<b>ADDENDUM TO THE CONTRACT DOCUMENTS</b>	<b>Page Number</b> 1	<b>No. of Pages</b> 12
<b>Addendum No. One (1)</b>	<b>Date Addendum Issued:</b> March 24, 2025	
<b>Issuing Office</b> Alaska State Parks, Design & Construction Section 550 West 7 <sup>th</sup> Avenue, Suite 1340 Anchorage, Alaska 99501 Phone: (907) 269-8736 Fax: (907) 269-8901	<b>Previous Addenda Issued</b> None	
<b>Project:</b> KRSMA: Kenai River Flats Facility Improvements <b>Project No.:</b> TA-21002/CFHWY00688	<b>Date &amp; Hour of Quotes Due:</b> April 2, 2025 2:00 PM prevailing time

### THE CONTRACT IS MODIFIED AS FOLLOWS:

Project Name: KRSMA: Kenai River Flats Facility Improvements

Project Number: TA-21002/CFHWY00688

ESTIMATE OF QUANTITIES,  
 ABBREVIATIONS & TABLE OF ESTIMATING FACTORS

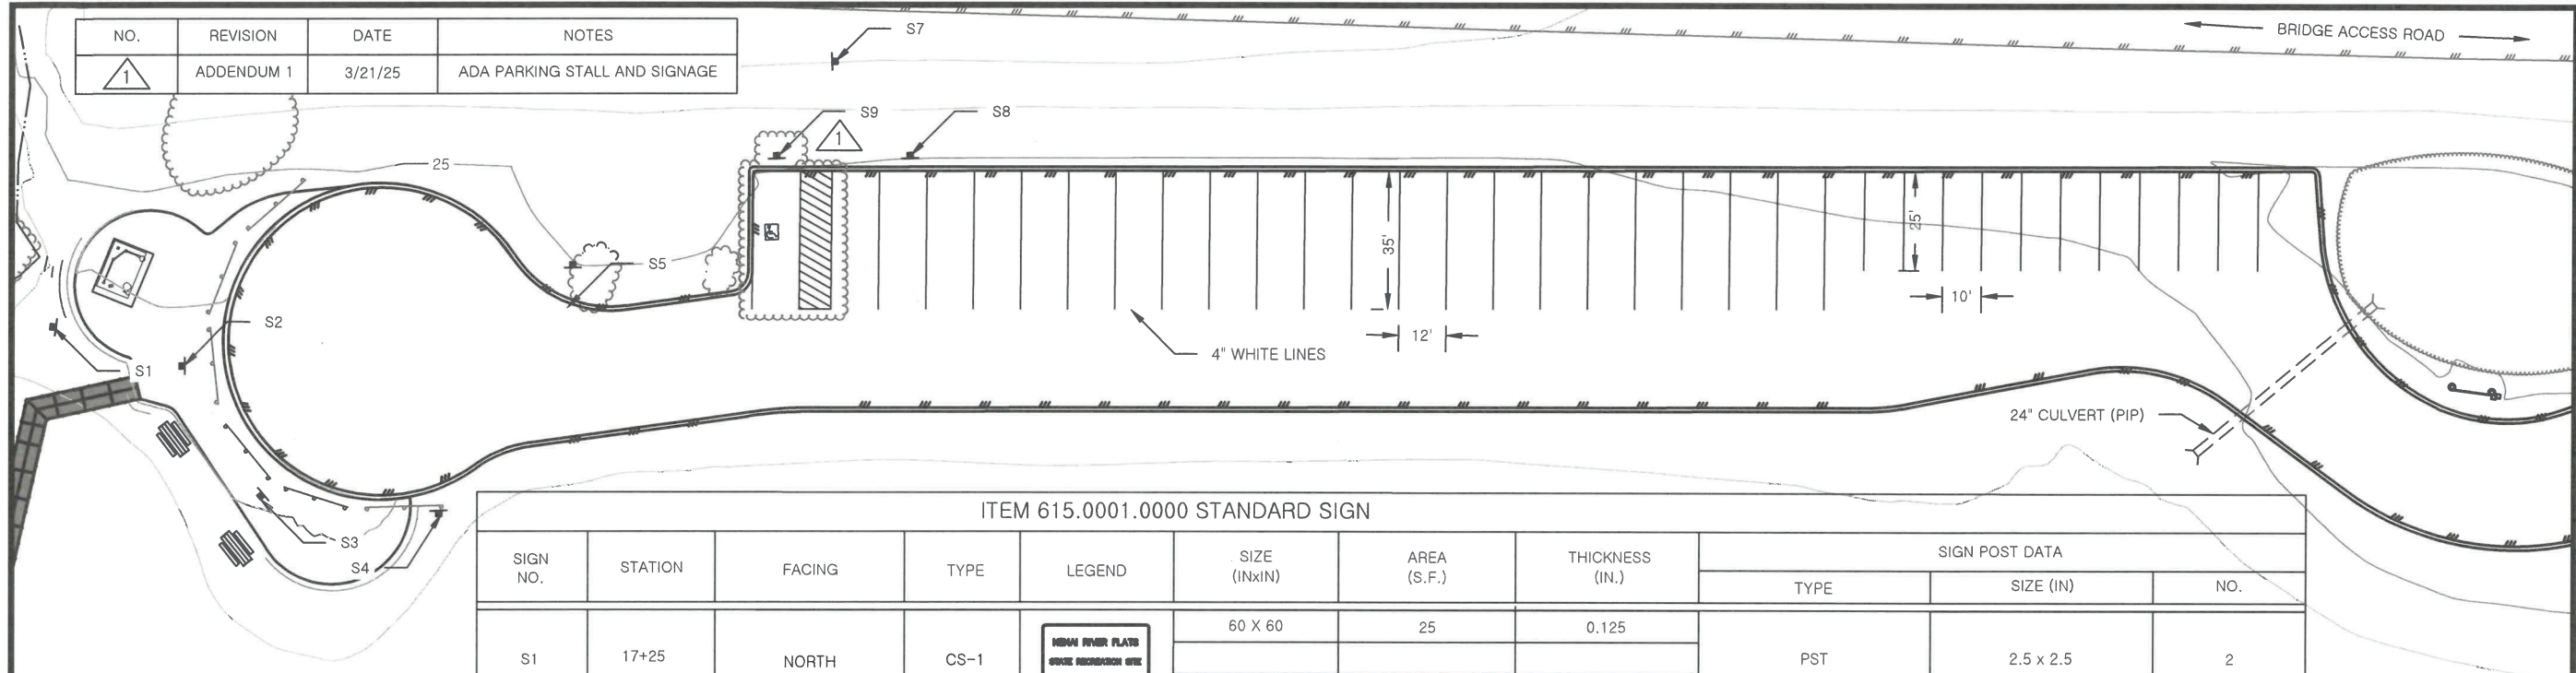
NO.	REVISION	DATE	NOTES
1	ADDENDUM 1	3/21/25	QUANTITY CHANGE

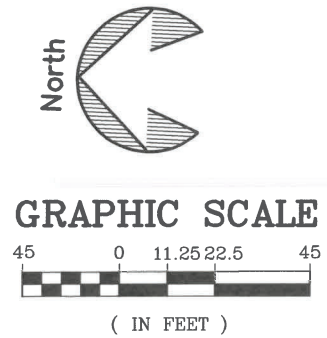
NO.	REVISION	DATE	NOTES
1	ADDENDUM 1	3/21/25	ADA PARKING STALL AND SIGNAGE

PARKING LOT TYPICAL SECTIONS

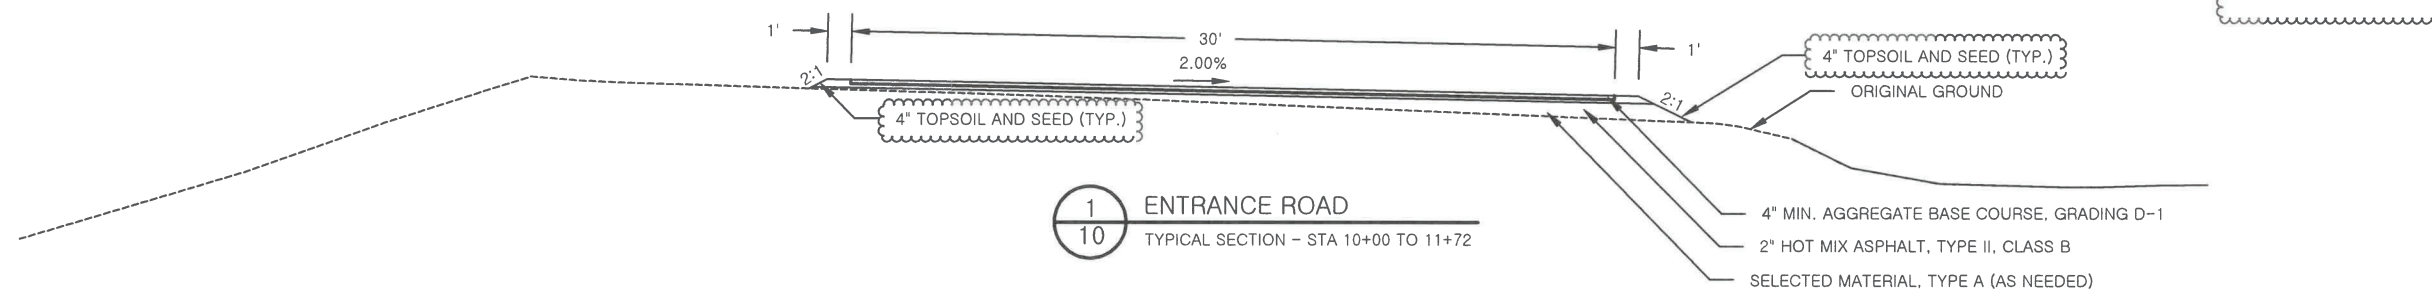
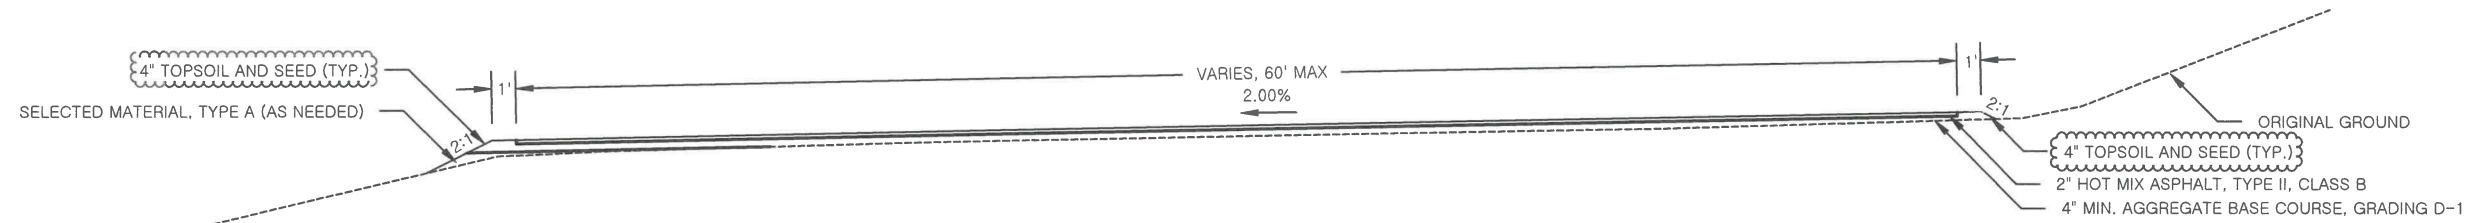
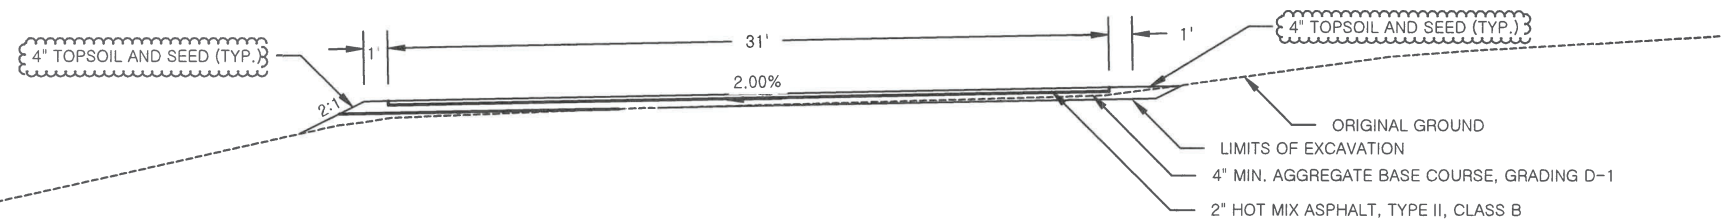
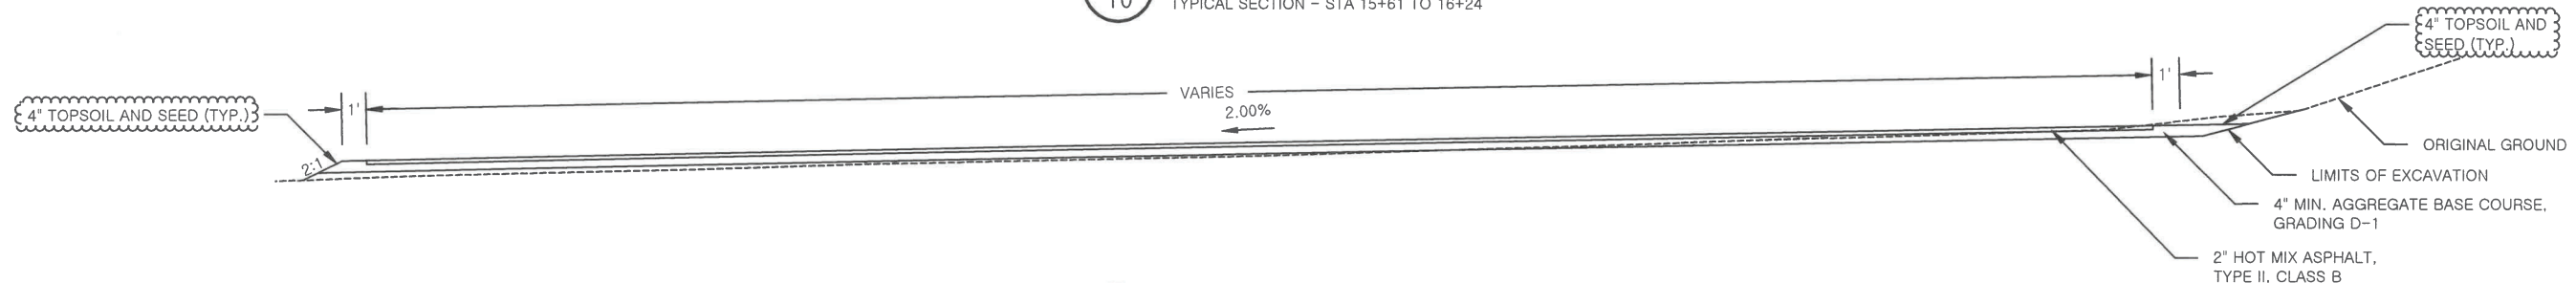
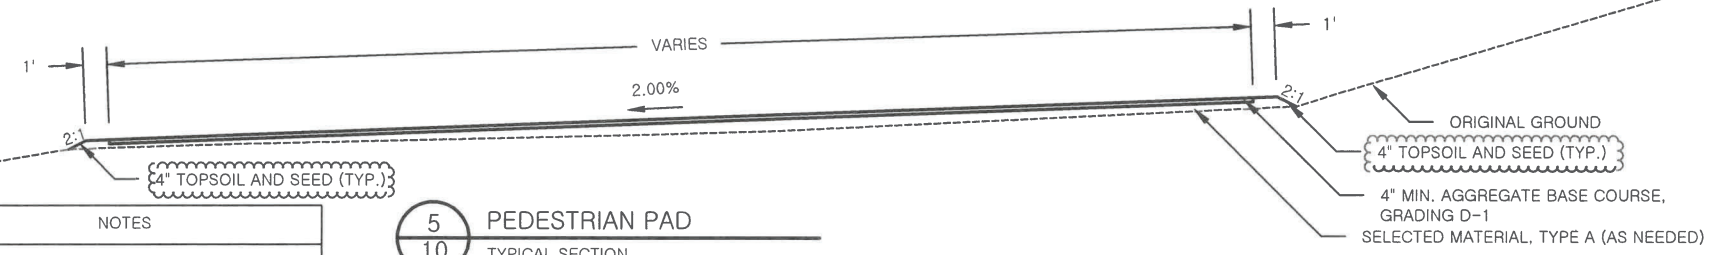
NO.	REVISION	DATE	NOTES
1	ADDENDUM 1	3/21/25	CLARIFY TOPSOIL AND SEED AREA

ELP WALKWAY PLAN AND PROFILE  
 STA. 22+00 TO 24+00

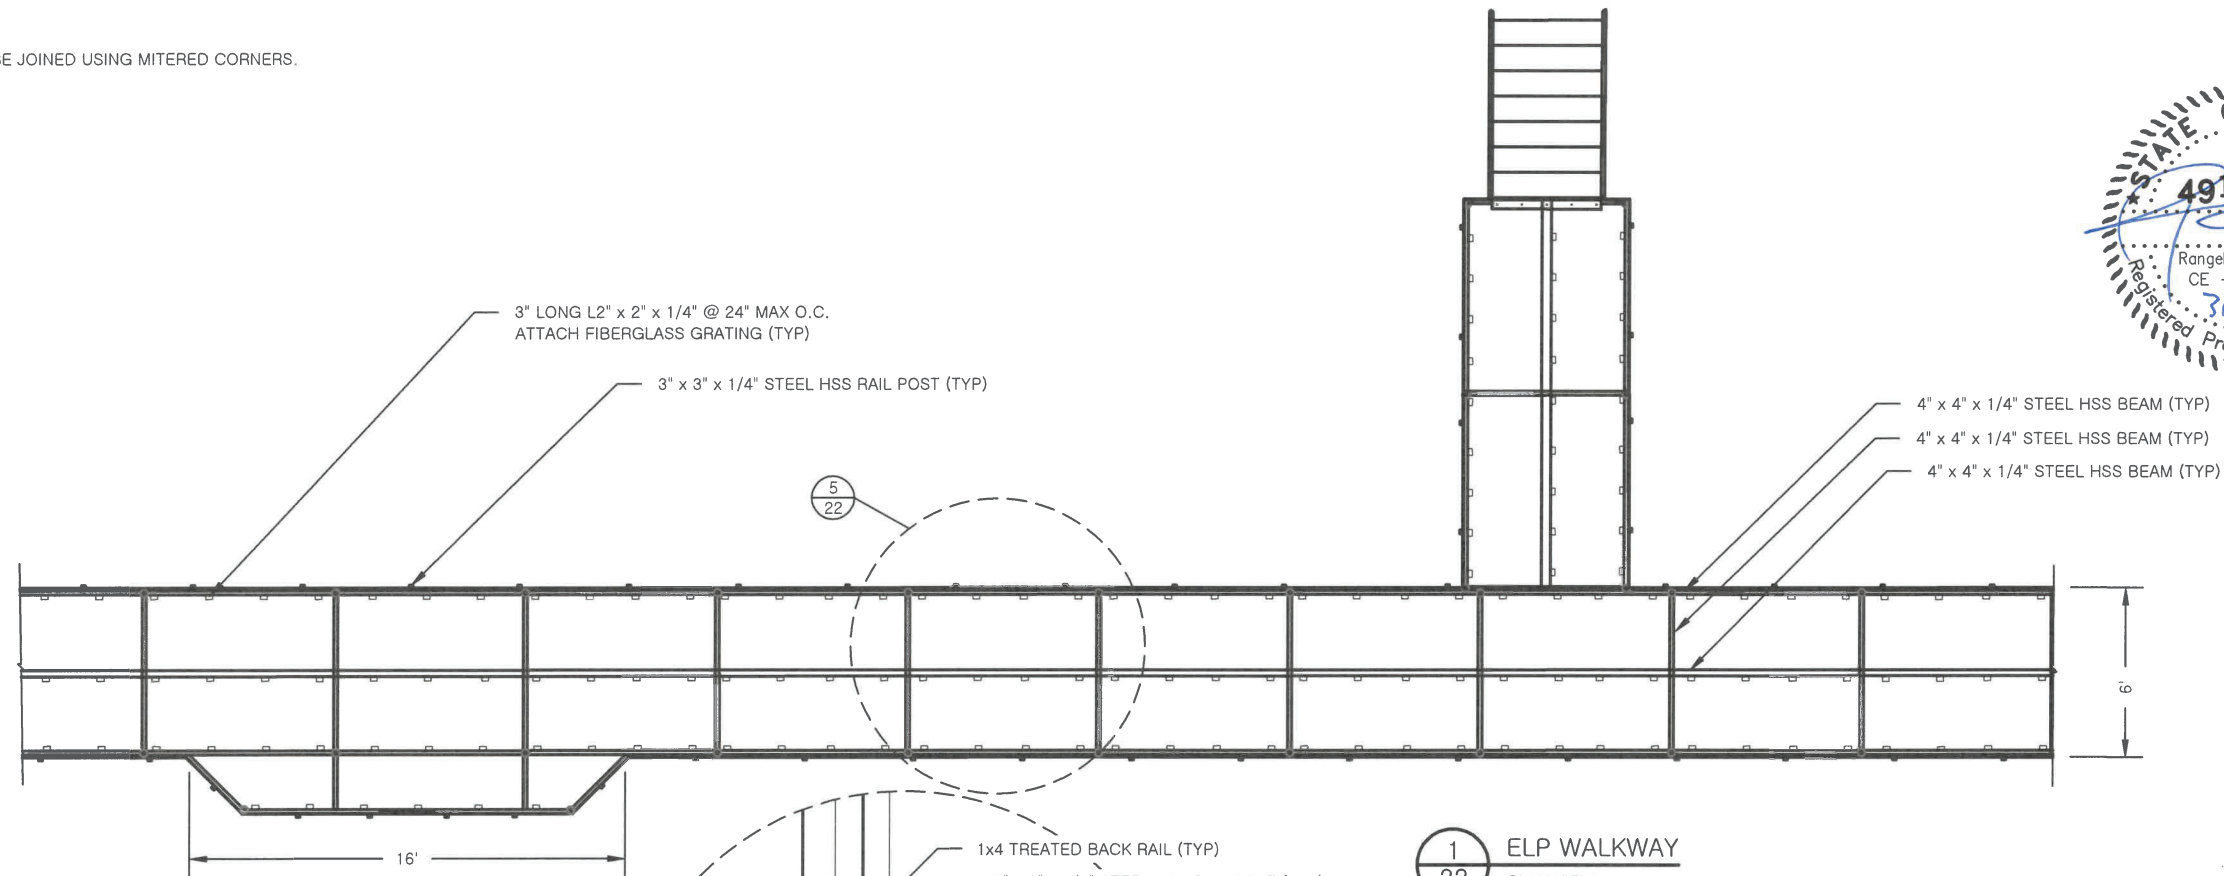
NO.	REVISION	DATE	NOTES
1	ADDENDUM 1	3/21/25	MODIFY TOP OF WALKWAY ELEVATION

ELP WALKWAY FRAMING DETAILS II

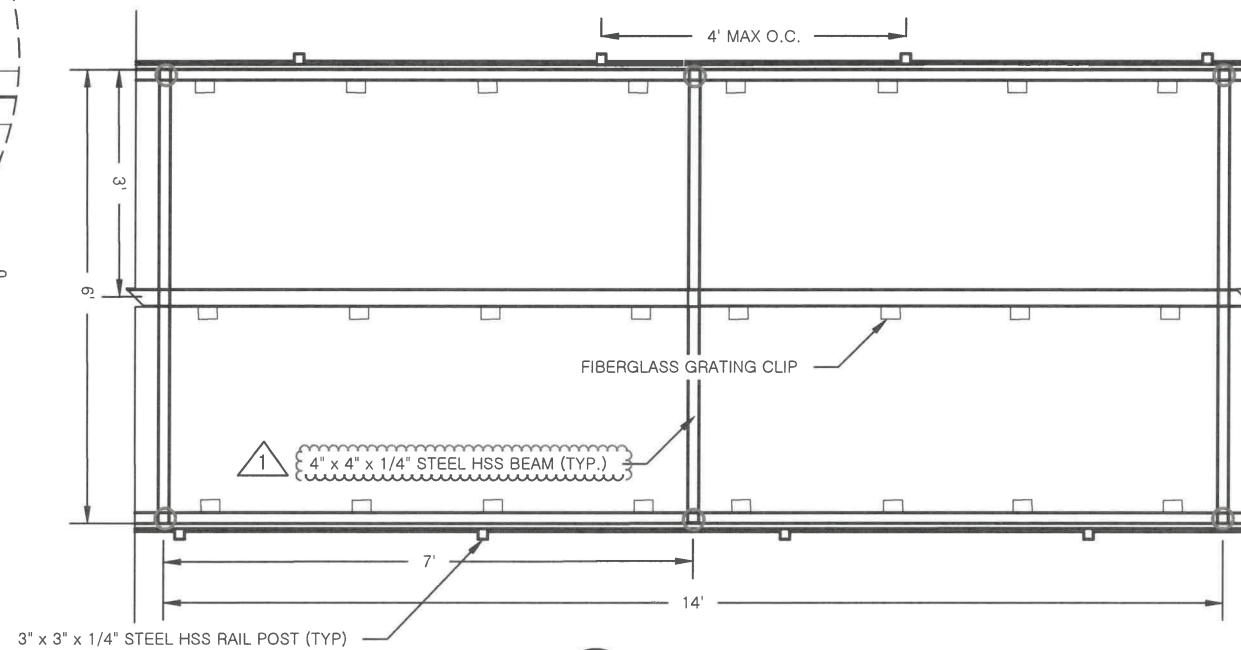
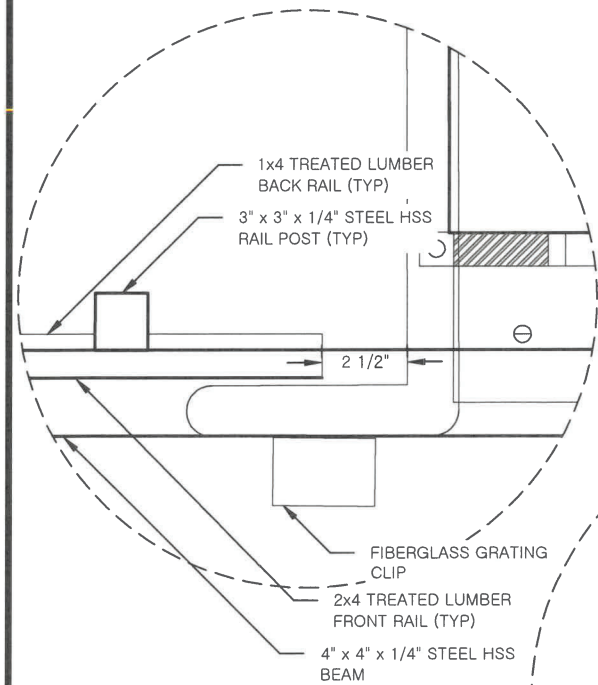
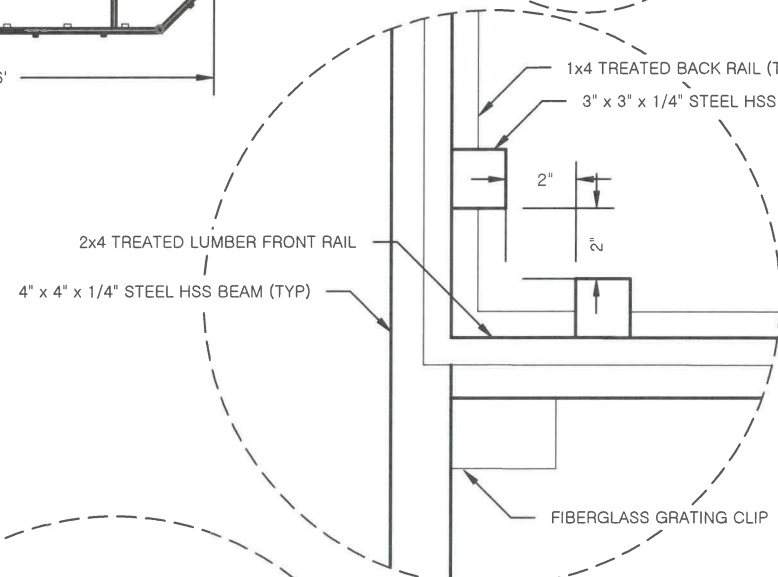
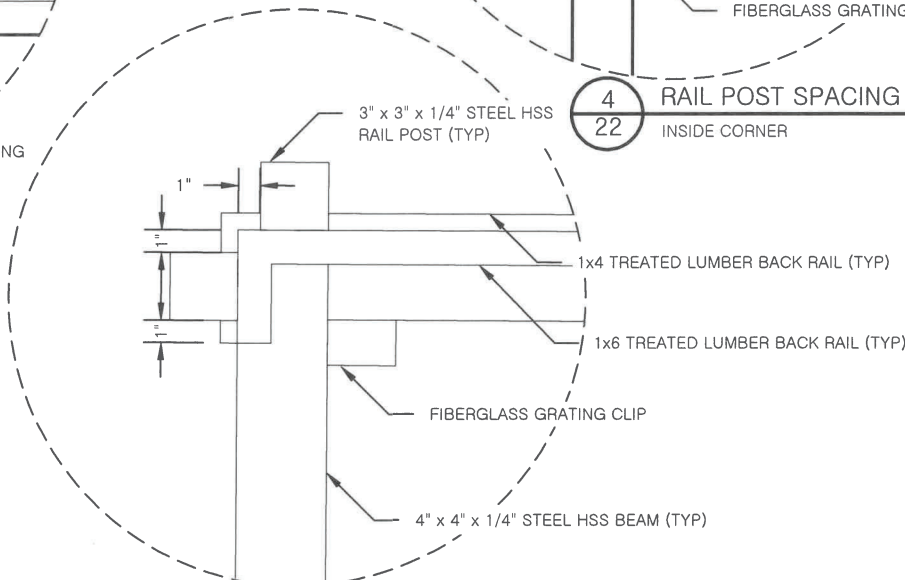
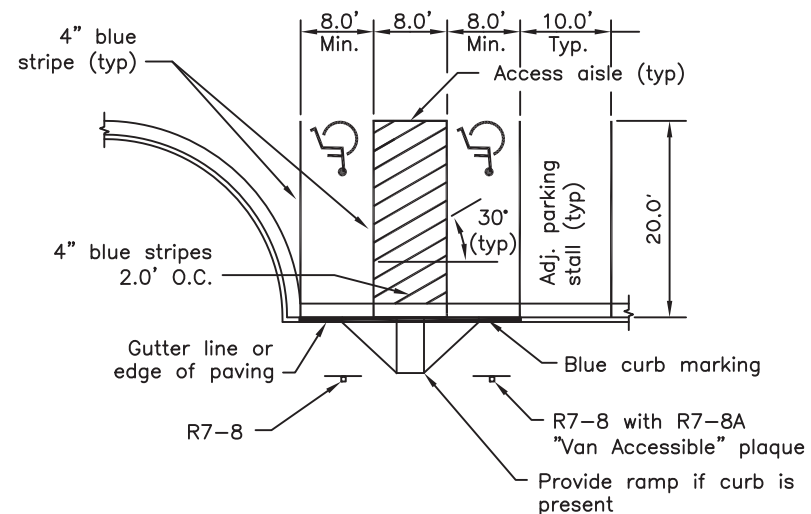
NO.	REVISION	DATE	NOTES
1	ADDENDUM 1	3/21/25	CLARIFY LOCATION OF 4" x 4" x 1/4" STEEL HSS BEAM ON ELP
